ALLEGHENY COUNTY SANITARY AUTHORITY

CONTRACT NO. 1729 G, E, H, P

EAST HEADWORKS

ADDENDUM NO. 1

WEST ELEVATION 1
SCALE: 1/8" = 1'-0"

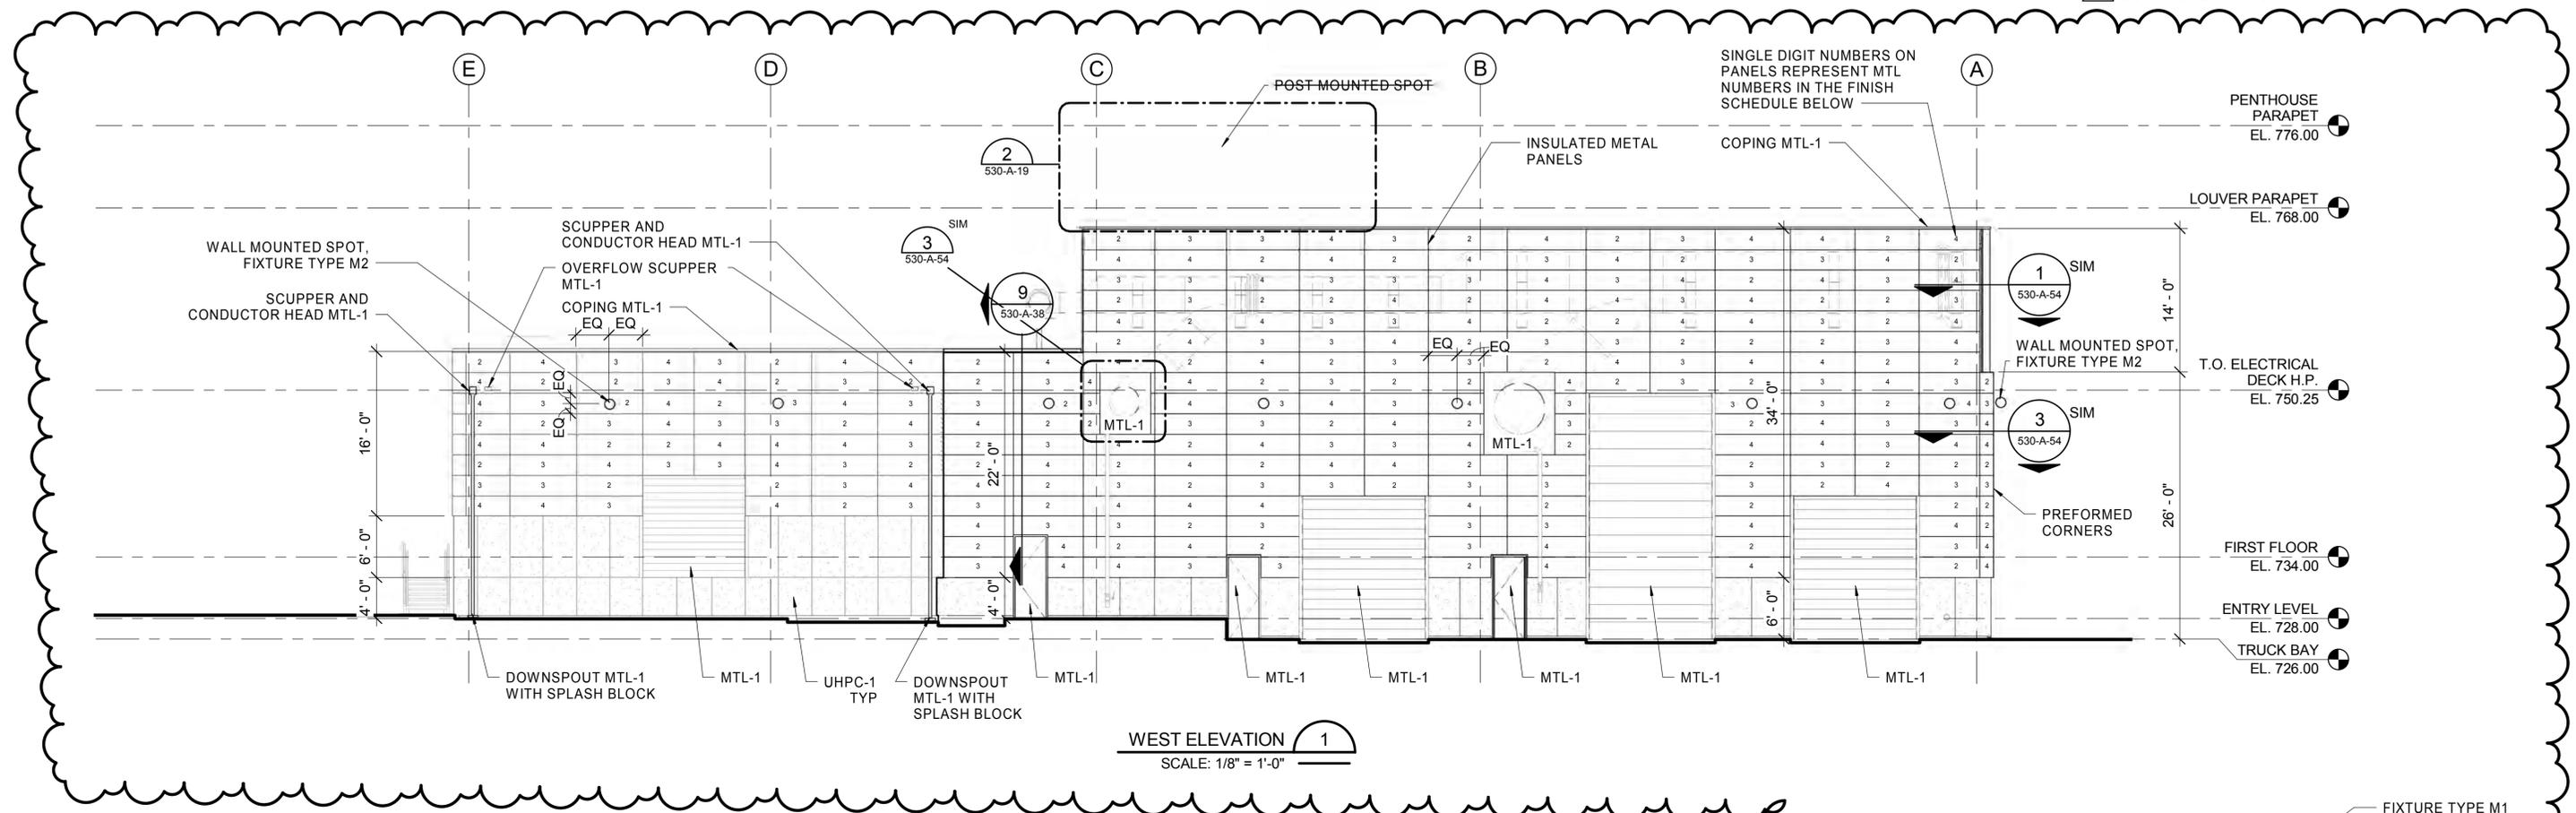
1 LIGHTING REVISIONS

NORTH ELEVATION 1
SCALE: 1/8" = 1'-0" 530-A-06

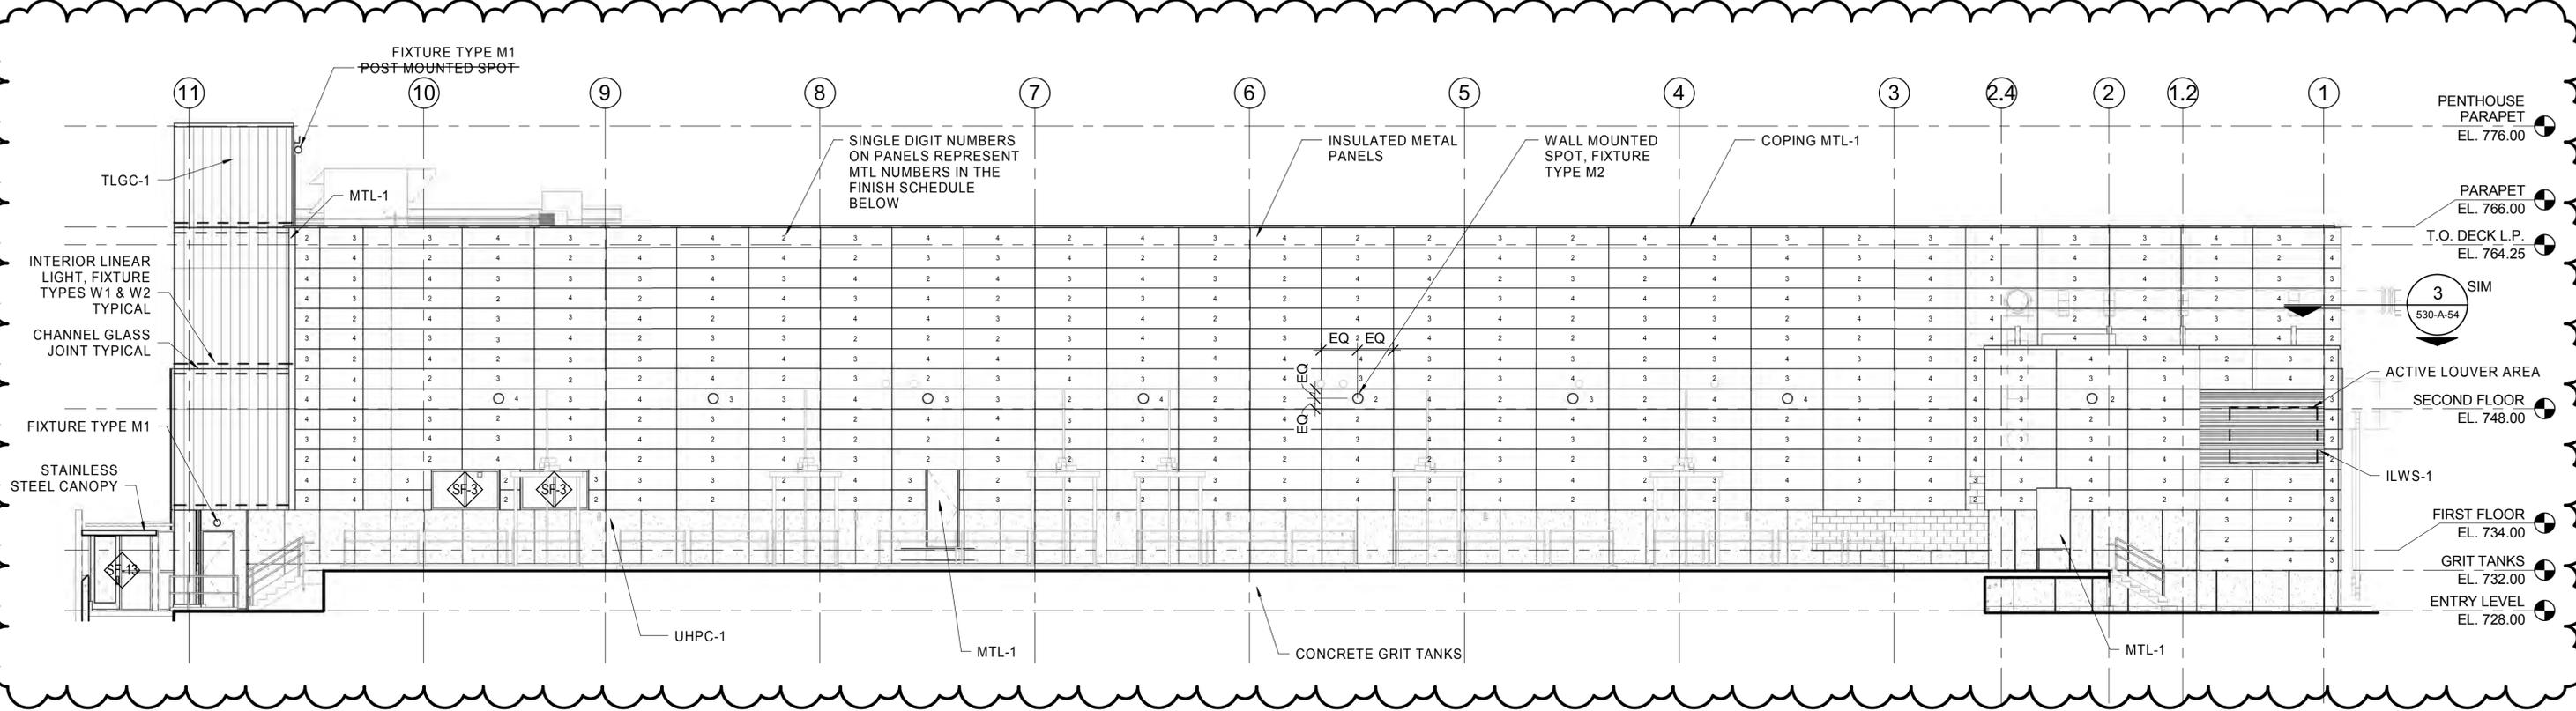
1 LIGHTING REVISIONS

ALLEGHENY COUNTY SANITARY AUTHORITY
WASTEWATER TREATMENT PLANT
EAST HEADWORKS
530-ELP-06
EAST HEADWORKS
FIRST FLOOR - LIGHTING PLAN AREA - C

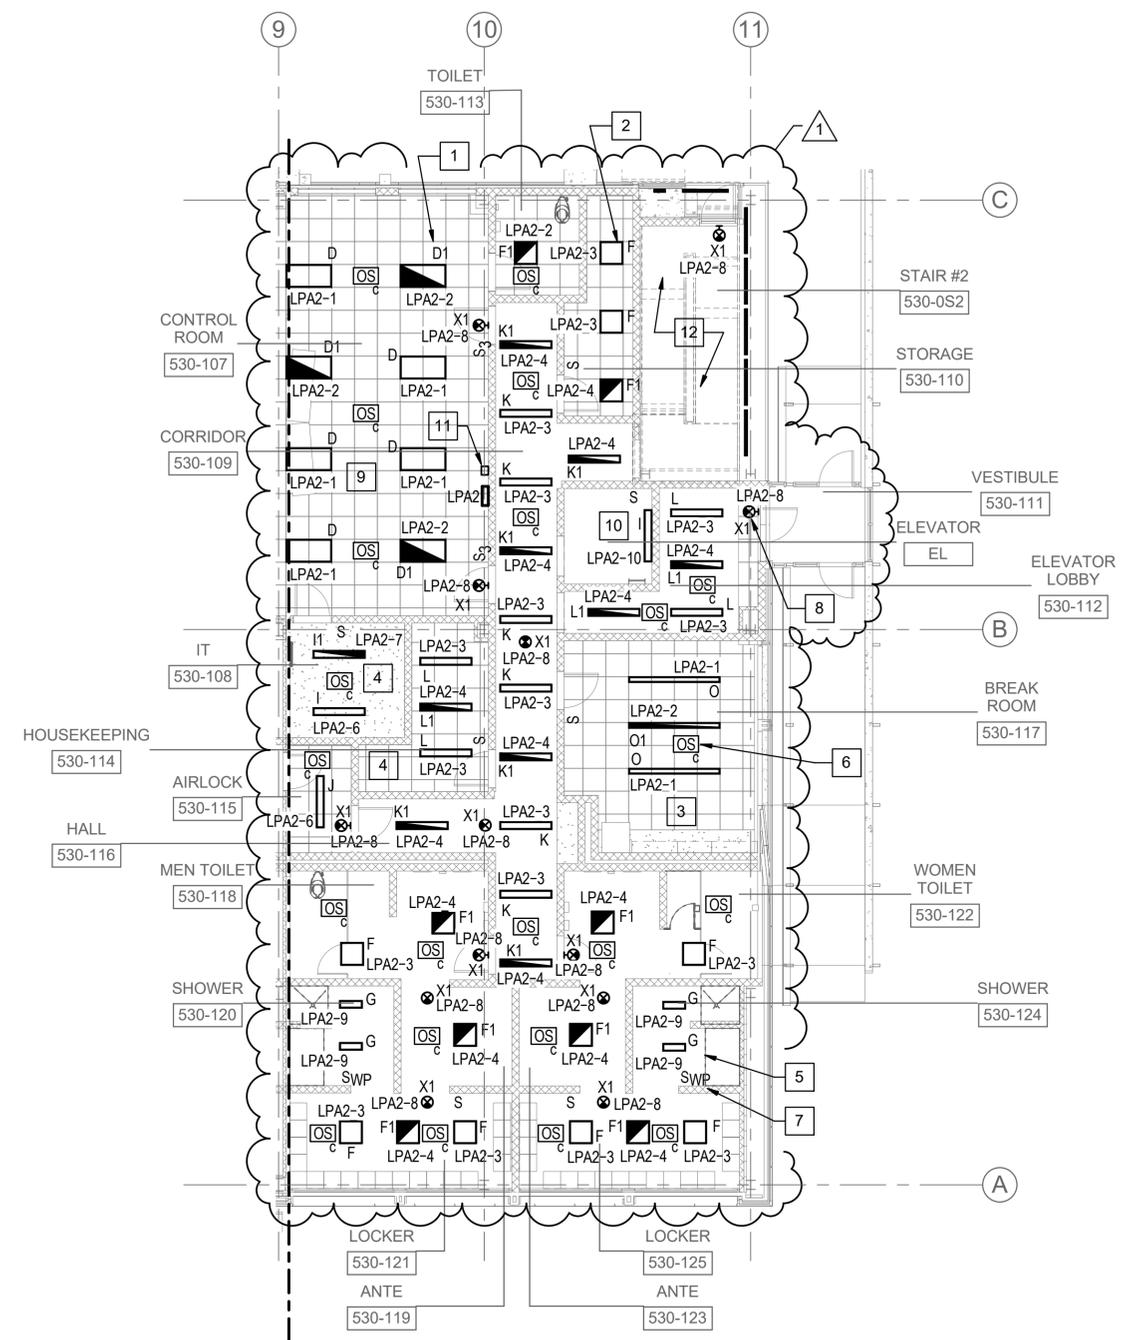
12. Drawing 530-ELP-06

- a) DELETE this drawing and REPLACE with the attached drawing 530-ELP-06.

EXTERIOR LIGHTING PLAN
SCALE: 3/32" = 1'-0"

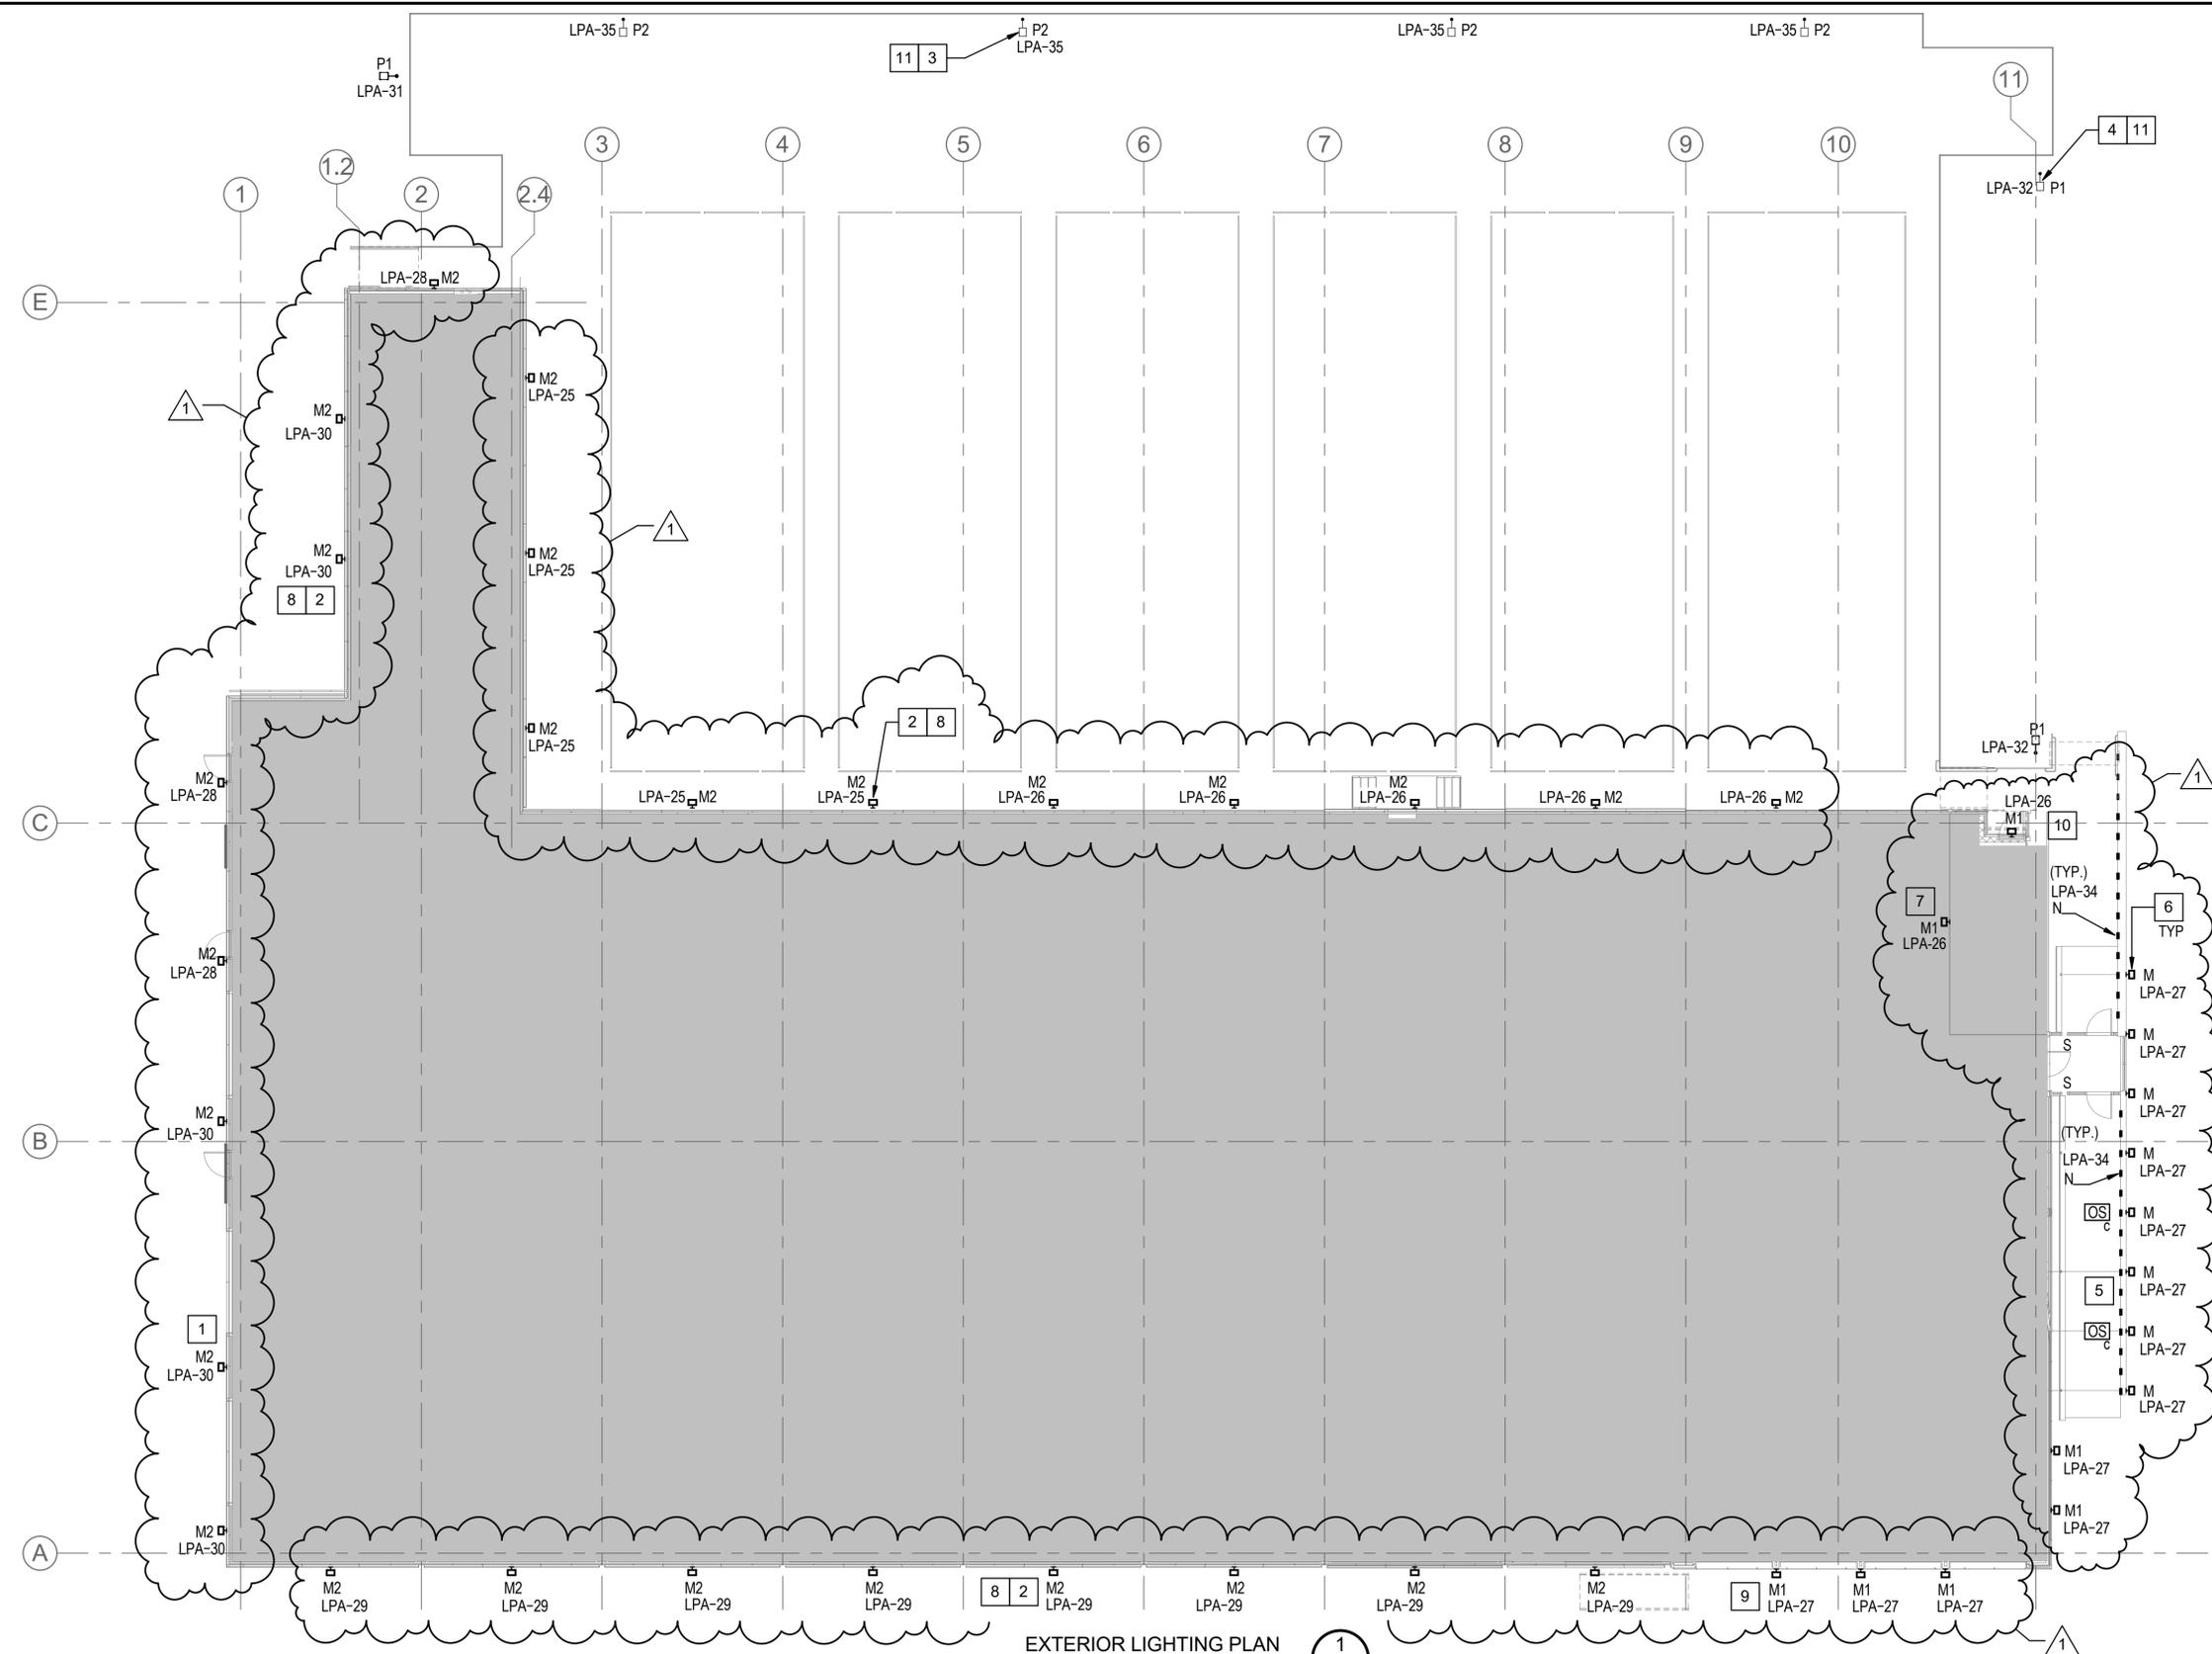
3. PROVIDE POLE AND LIGHT FIXTURE COMBO. INSTALL THE 25 FEET POLE ON THE NORTH END OF THE GRIT TANK. RUN CONDUIT TO THE LIGHTS ALONG STRUCTURAL SUPPORT MEMBER UNDER GROUND. CONTROLLED THE SAME WAY AS THE GENERAL EXTERIOR WALL FIXTURES. COORDINATE WITH STRUCTURAL / CIVIL FOR MOUNTING OF THE POLE BASE ON THE CONCRETE SLABS.

4. INSTALL ROADWAY STYLE LIGHTING FIXTURE ON A 25' TALL ALUMINUM POLE. SEE DETAILS ON DRAWING 530-ELD-01 (TYPICAL OF 3). CONTROLLED THE SAME AS THE GENERAL WALL MOUNTED FIXTURES.

5. INSTALL LIGHTING TYPE N RECESSED ON EAST WALL OF THE CANOPY. CONTROLLED BY LOW TEMPERATURE SENSORS AND A SWITCH AT THE ENTRANCE. RUN CONDUIT CONSEALED UNDER SLAB AND UP THE WALL. SEE DRAWING 530-A-45 FOR DETAILS.

6. INSTALL LIGHTING FIXTURE TYPE M ON THE CANOPY STRUCTURE. RUN CONDUIT IN WALL AND UNDER SLAB. CONTROLLED BY PHOTOCELL. SEE ARCHITECTURAL DRAWING FOR MOUNTING DETAILS.
